**REGULAR MEETING OF THE UNITED LAGUNA HILLS MUTUAL
ARCHITECTURAL CONTROL AND STANDARDS COMMITTEE**

Tuesday, November 28, 2017

DATE: November 28, 2017
FOR: Architectural Control and Standards Committee
SUBJECT: Variance Request: Paul S Scottberg, 271-B (Majorca, Plan 9)
Bathroom Remodel

DATE: November 28, 2017
FOR: Architectural Control and Standards Committee
SUBJECT: Variance Request: Jean Maroney of 413-A (Madrid, 4)
Bathroom Addition, Change of Room Use, Window Addition, and
Installation of Resized Window in Living Room

Existing closet

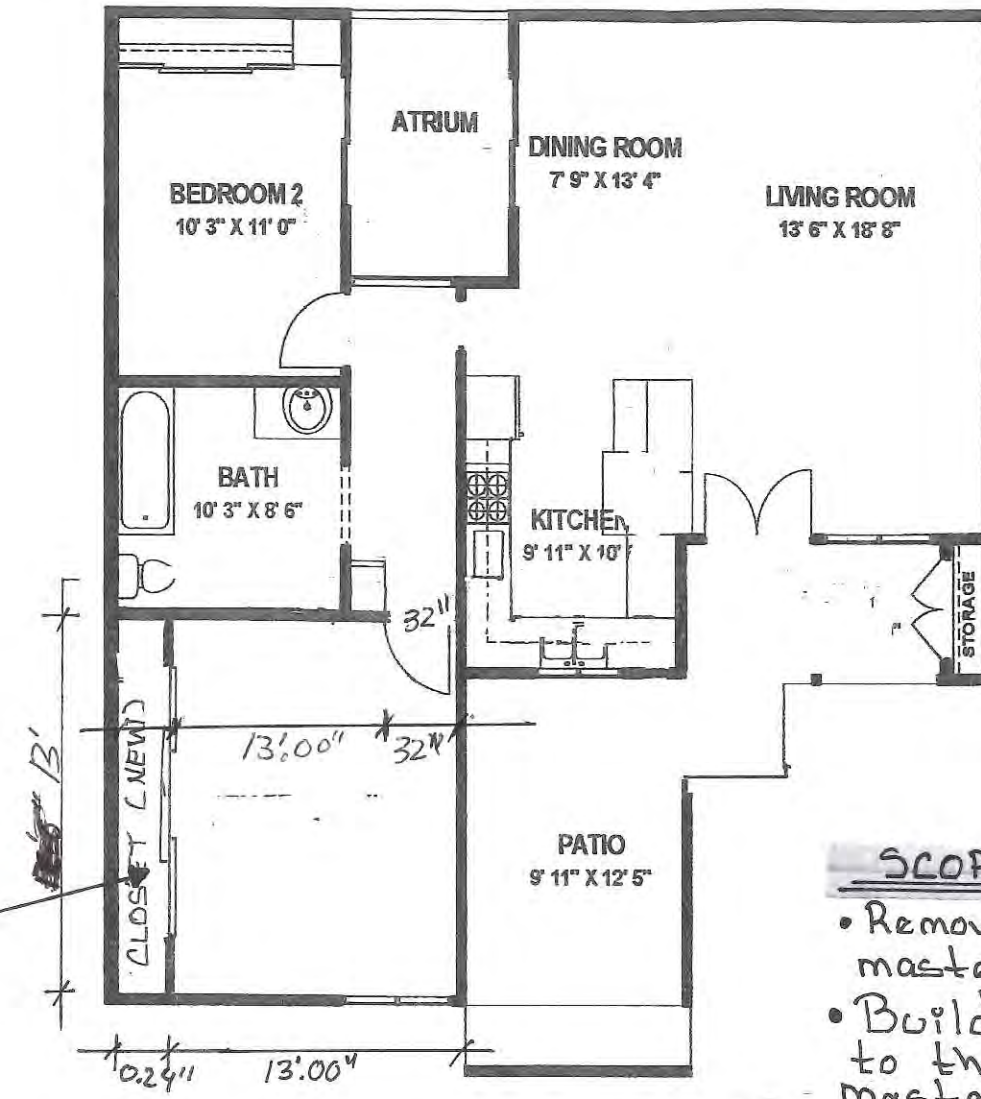
Mr. Cronin proposes to remove the existing clothes closet and water heater closet that abut the bathroom and install a new closet along the adjacent wall. The water heater will be relocated via an over-the counter Mutual Consent.

- Remove Existing closet in master bedroom
- Build new closet 2' x 15' to the left of the master bedroom

EXISTING FLOOR PLAN MATORCA

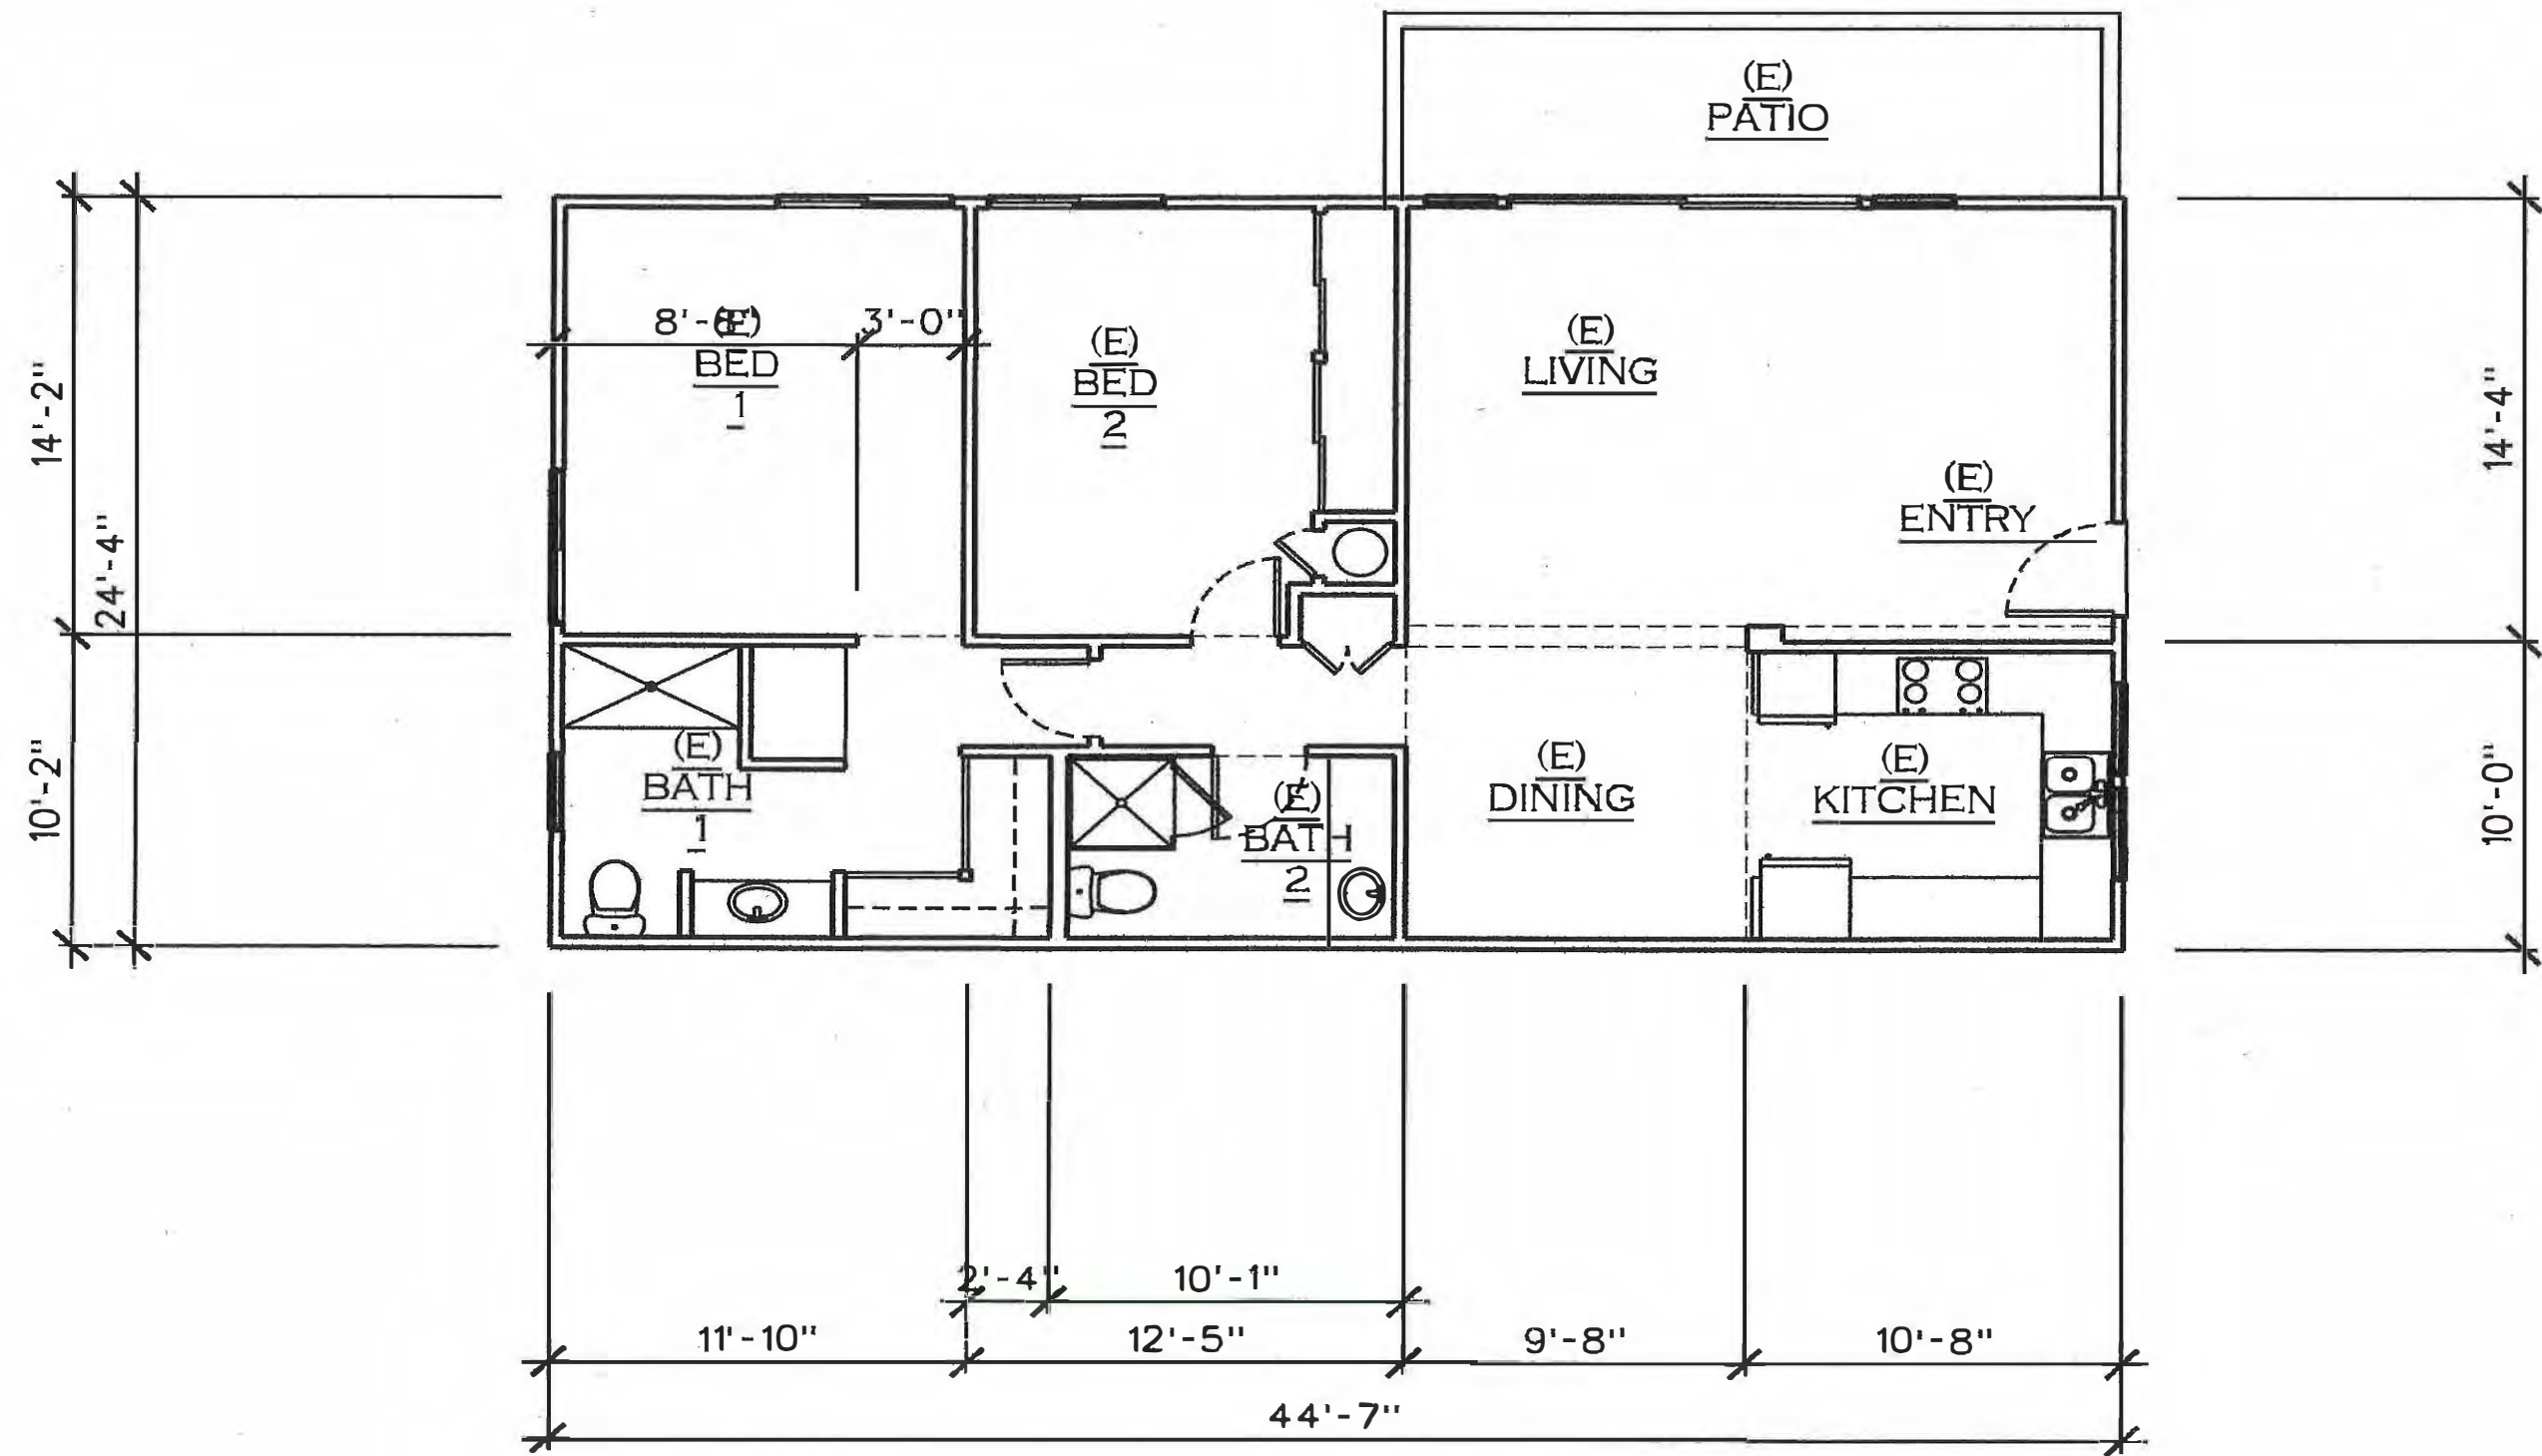
The proposed floor plan of the second bathroom indicates the relocation of the shower, tub, and sink, while reducing the size of the vanity. These changes enable the installation of a closet for a stackable washer-dryer, accessible from the hallway.

Masterbathroom	Reduce Existing Shower from 60" to 54.25" adding partition wall
	Build partition wall over existing linen closet door
	Build partition wall in place of closet entrance
2nd bathroom	Relocate existing toilet to opposite wall next to vanity
	Relocate existing shower to original toilet location
	Create Washer/Dryer space in existing shower location

EXISTING Floorplan

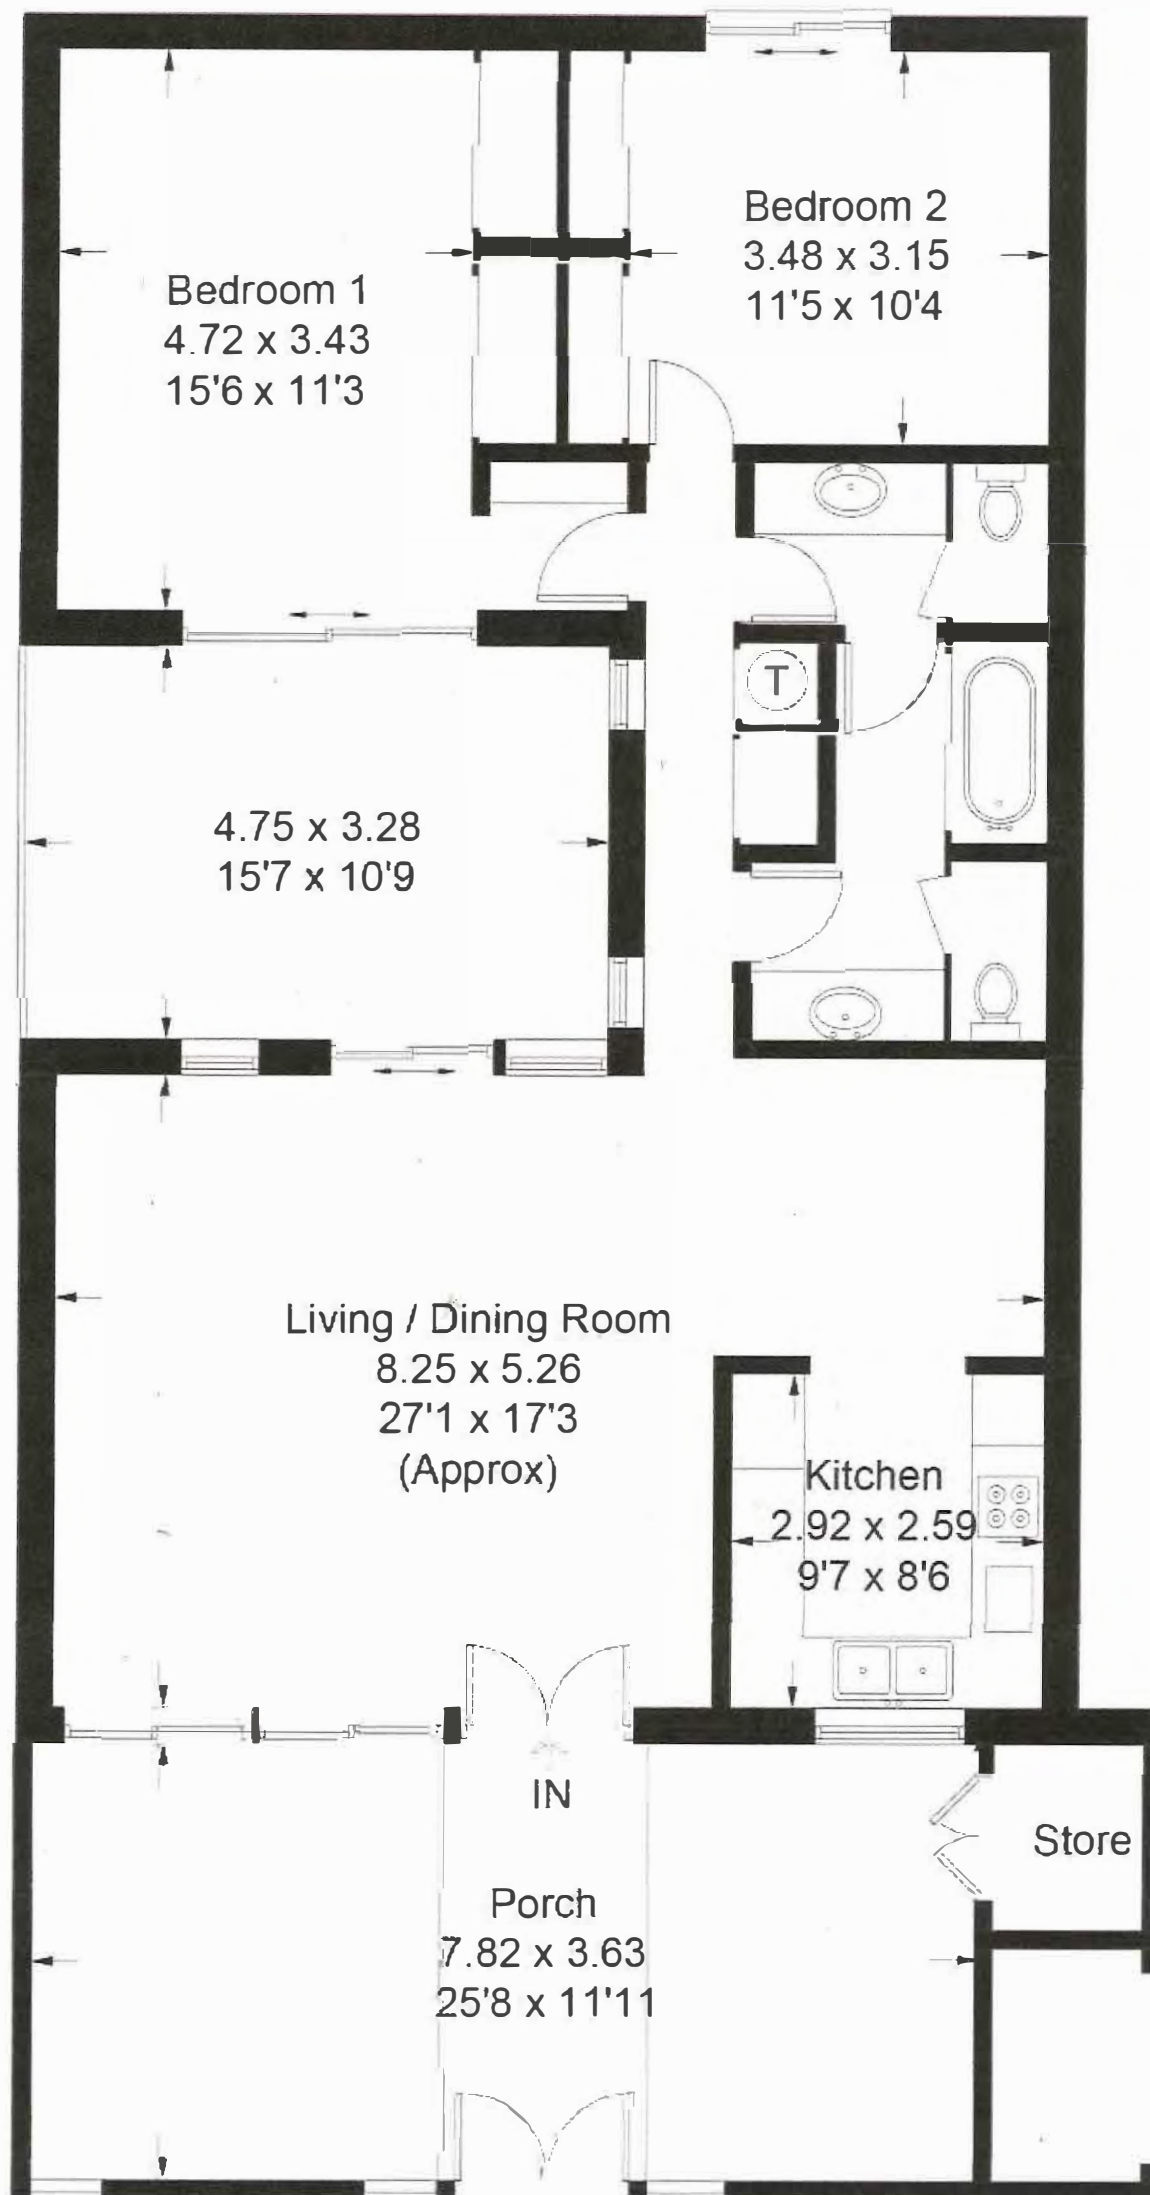
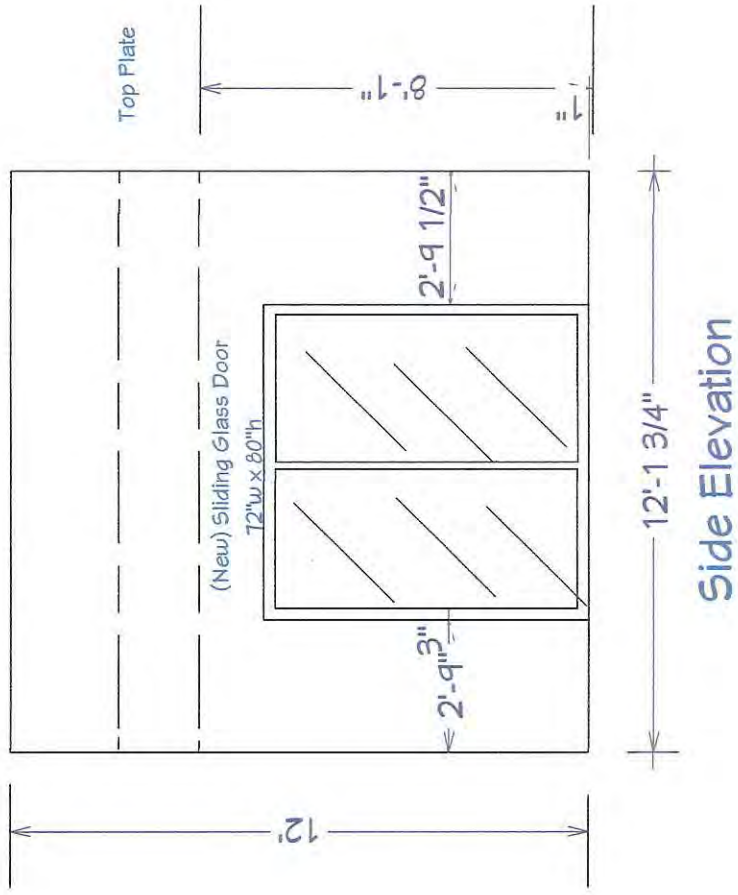
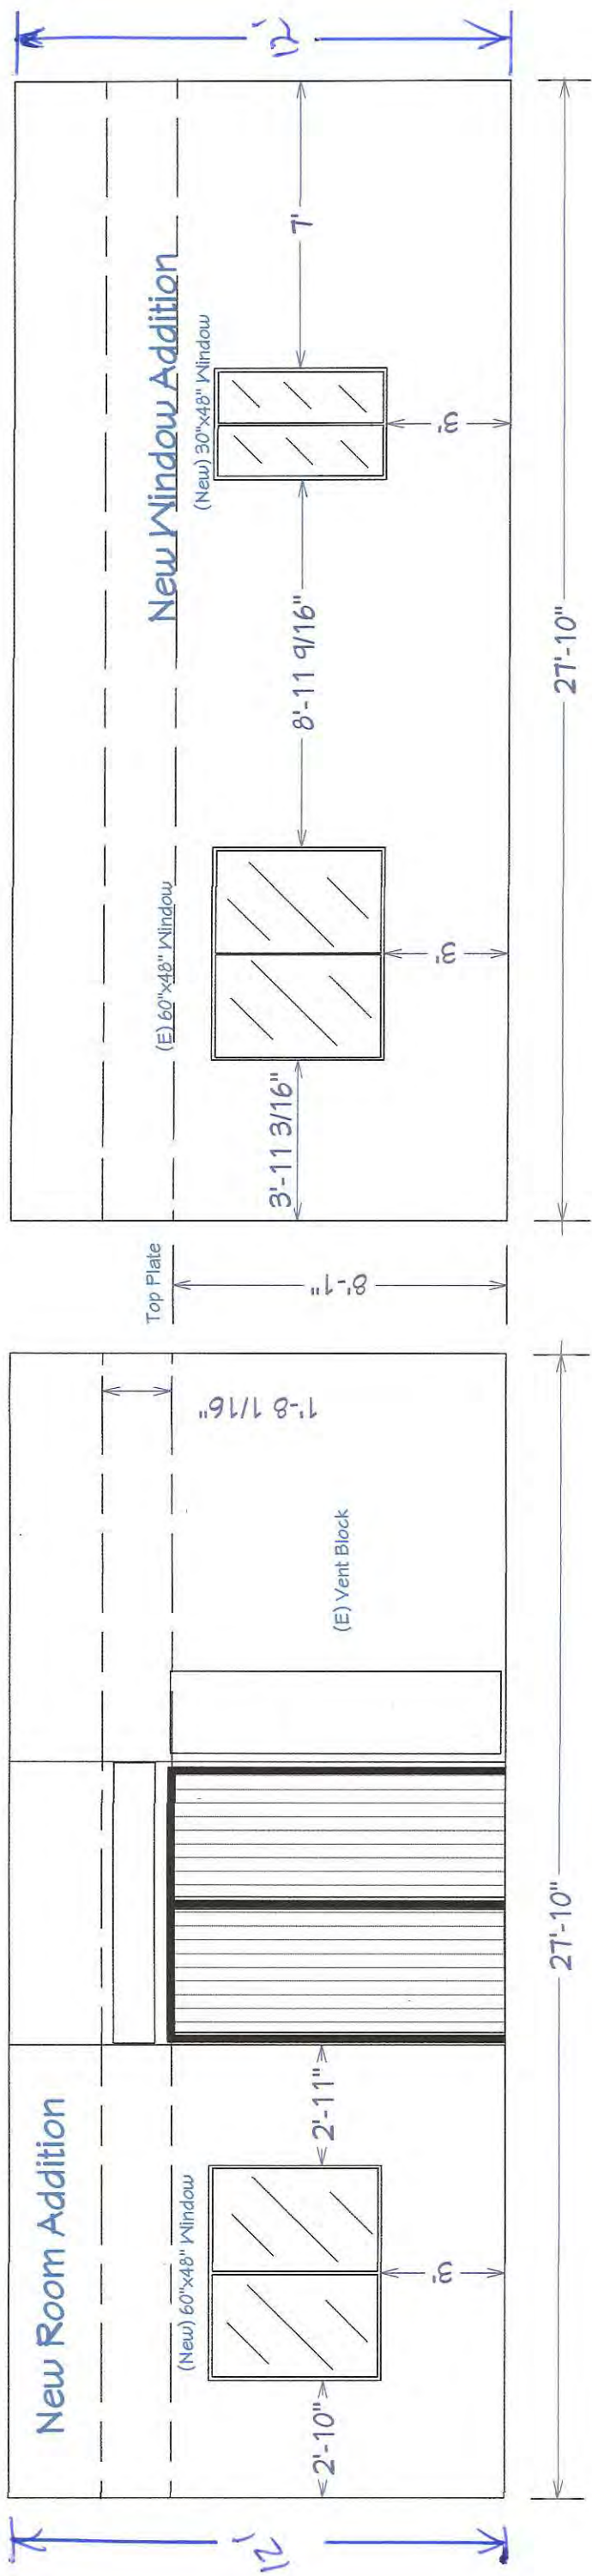
There are Architectural Standard plans for a breakfast room addition and a full patio room addition (plans 7 and 8 respectively), however the proposed room addition for 311-B is in front of the living room rather than kitchen. Due to the proposed room addition not quite matching the standard plan, a Variance was required.

There is an Architectural Standard plan for a window addition in the master bedroom, requiring a window which is 5 feet wide by 5 feet high. Due to the existing guttering and electrical panel locations, the Standard size window would not be possible.

Ms. Fine also proposes to add a window the master bedroom measuring 30 inches wide by 48 inches tall. While this size window is not in an existing standard, there are multiple

- 1) ROOM ADDITION - EXTEND LIVING ROOM WALL OUT TO ENCLOSED STUCCO PATIO WALL. CREATE NEW OFFICE WITH 1 WINDOW AND 1 SLIDING GLASS DOOR TO EXISTING PATIO. TO MATCH EXISTING ROOF LINE
- 2) ADD (1) 30"W x 48"H WINDOW IN MASTER BEDROOM WINDOW WILL BE PLACED BETWEEN ELECTRIC PANEL & DOWN SPOUT
